RE: **Monterey Place Apts**
2306-2320 Central SW
Grading Plan Stamp Date: 11/13/19
Drainage Report Stamp Date: 11/13/19
Hydrology File: J12D030

RE: Monterey Place Drainage Submittal for Building Permit (Hydrology File: J12D030)

RE: Monterey Place Apartments (Hydrology File J12D030) Revised Grading and Drainage Plan

STORM A
P-PRO

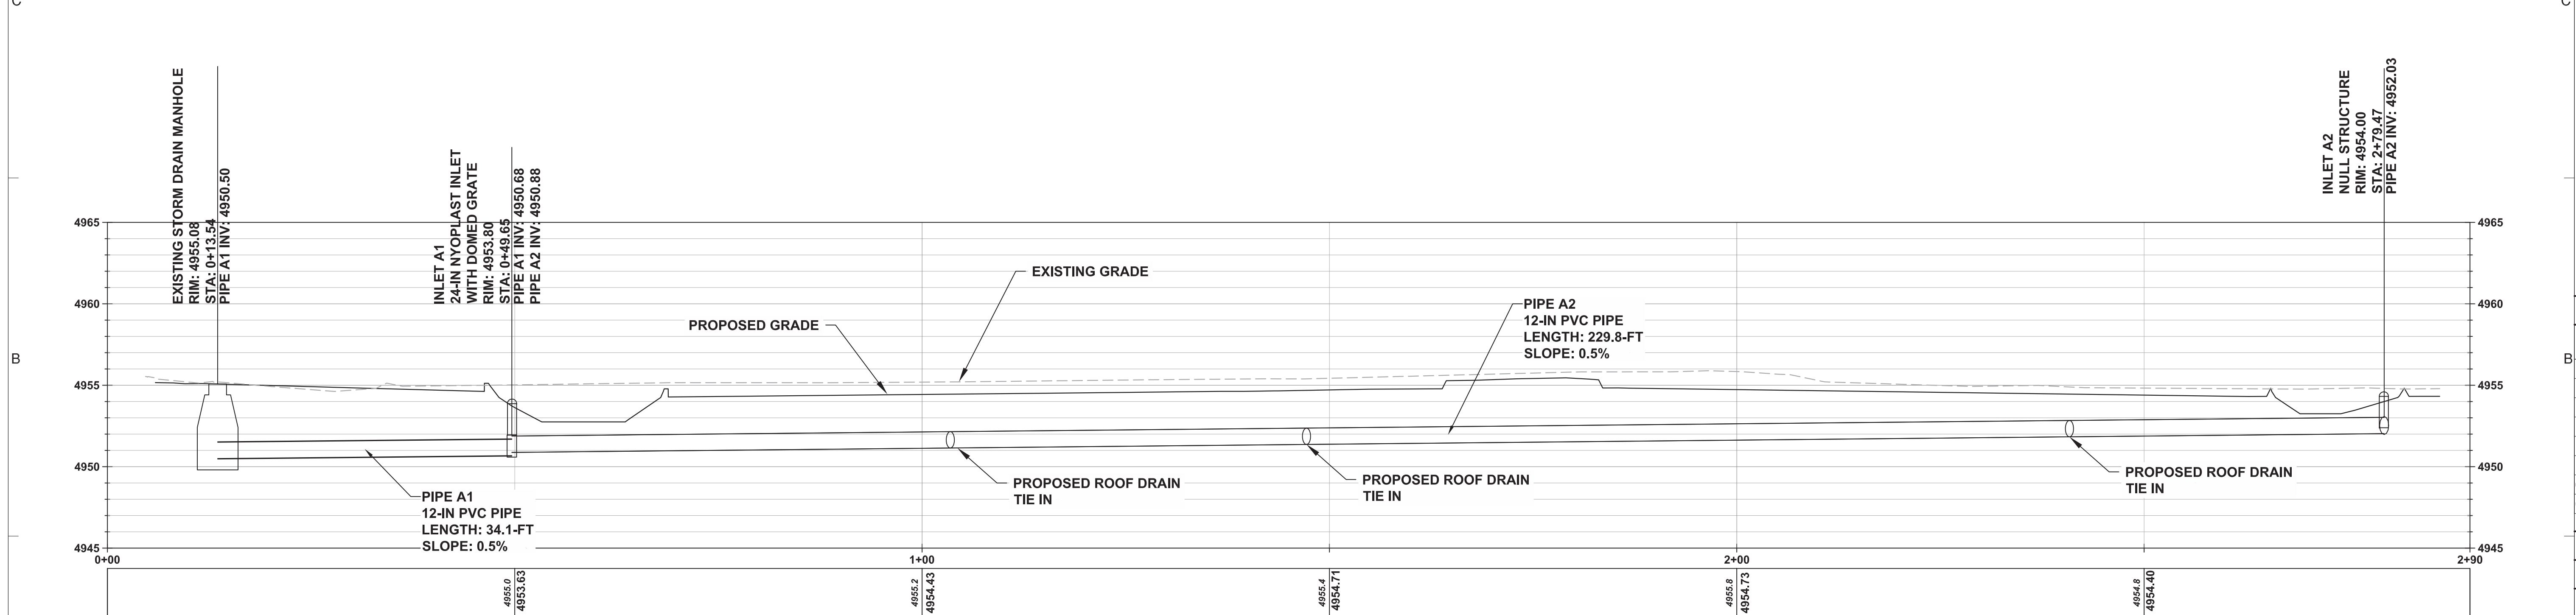
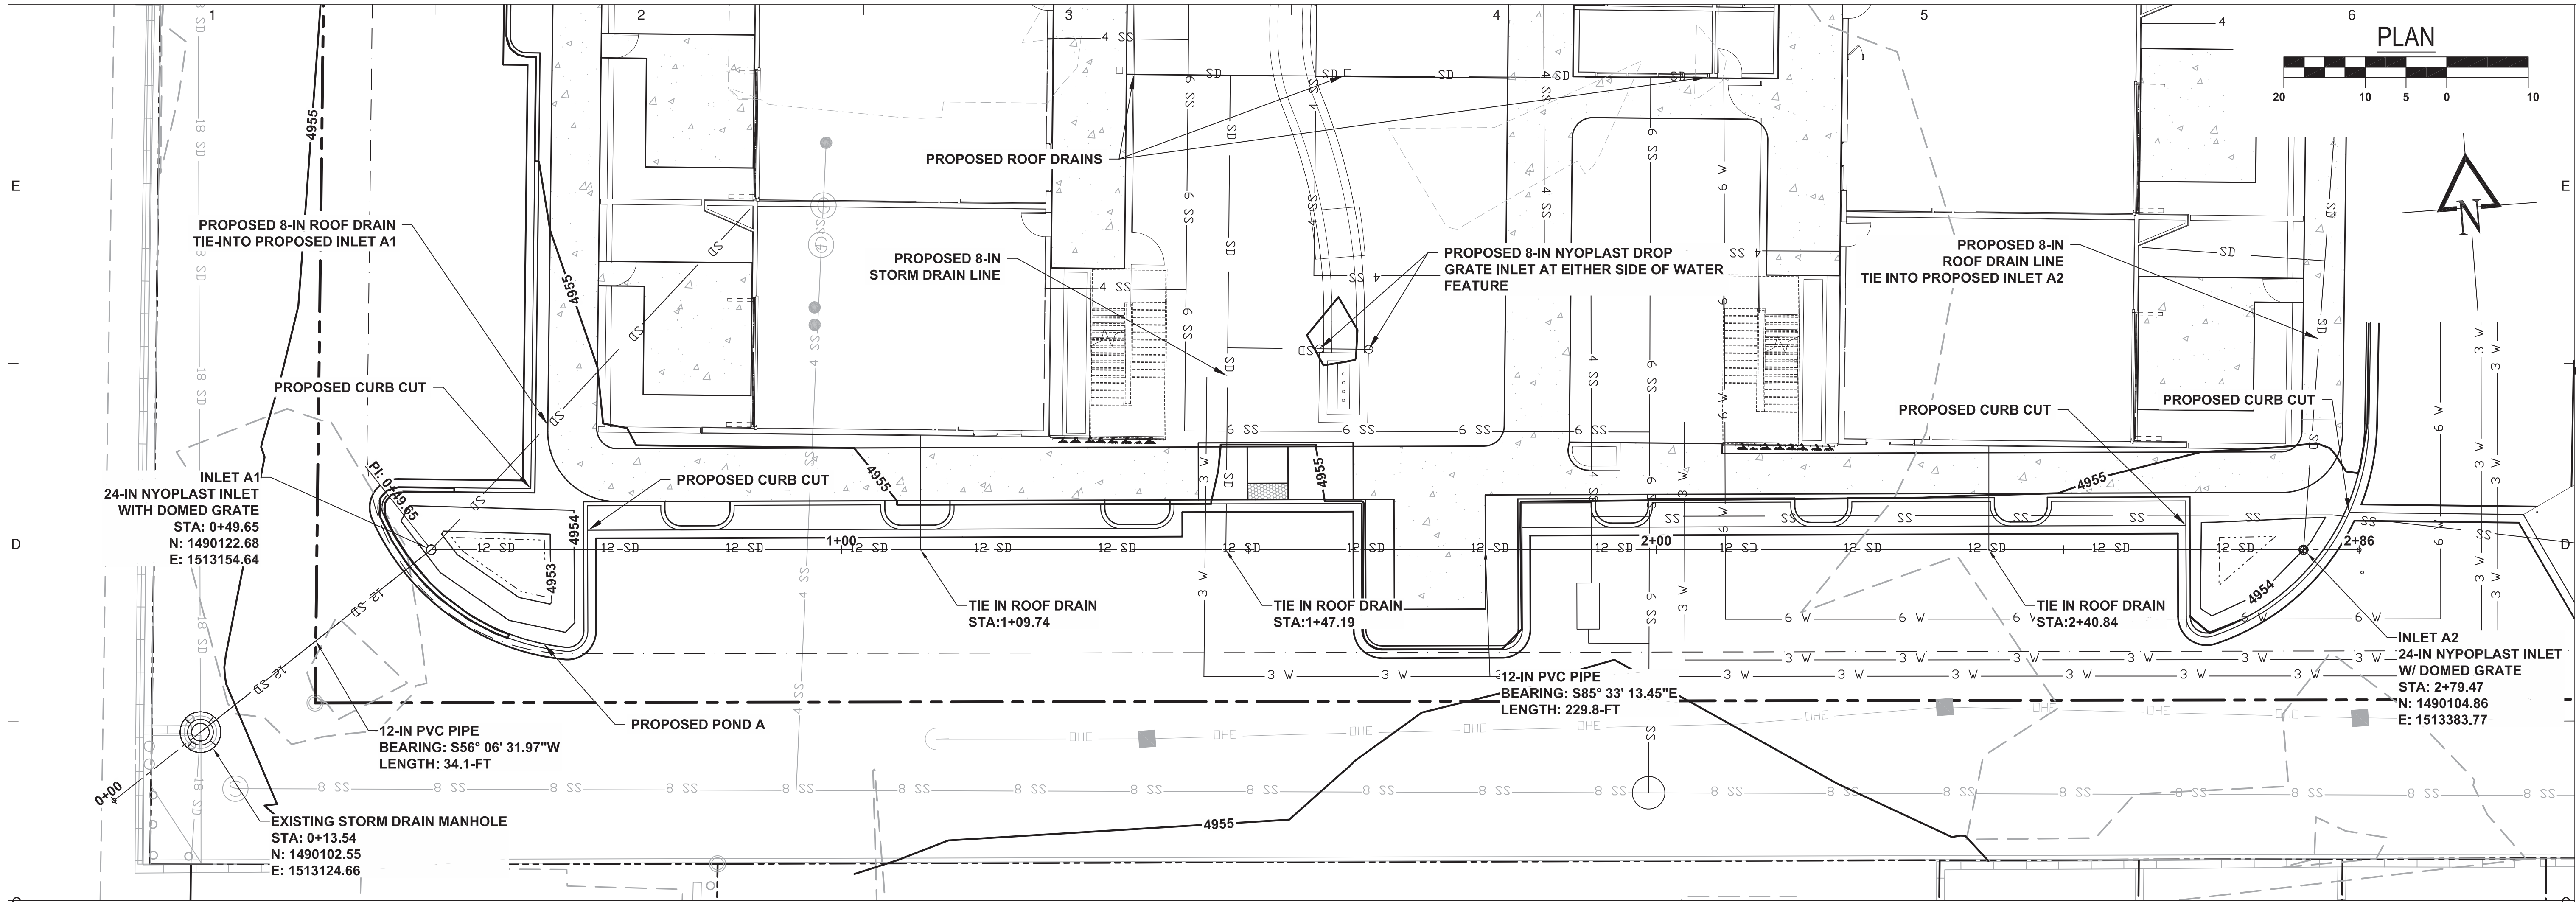
Recent field discoveries have prompted the need for a minor revision to the Grading and Drainage Plan, approved November 21, 2019, for the Monterey Place Apartments. In short, an existing storm drain manhole was discovered in the SW corner of the alley that was previously unknown. This manhole is downstream of the inlets in Central Avenue, proposed to be tied into per the approved plan.

- Overall improved internal storm drain system (outlet is now at the low point of the site, there is less opportunity for clogging and the tie-in is 6-in above City storm main invert for less opportunity for back up)
- Reduced impact to Central Avenue Right-of-Way
- Reduced chance of utility conflicts with existing utilities in Central Avenue ROW

“Two separate 12-in PVC storm drain lines were designed to convey flow from the site to the existing City storm drain system. Storm Line A was designed to collect flows from Basins A and B and convey them to an existing storm drain manhole at the southwest corner of the site. Storm Line B was designed to collect flows from Basin D and convey them to an inlet in Central Ave. The *Hydraflow Storm Sewer Extension for AutoCad Civil3D 2018* was used to model each of the proposed storm drain lines and calculate the Hydraulic Grade Line of each system during the 100-

year storm. *Storm Sewer* output is attached and demonstrates the HGL remains in the pipe during the 100-year storm."
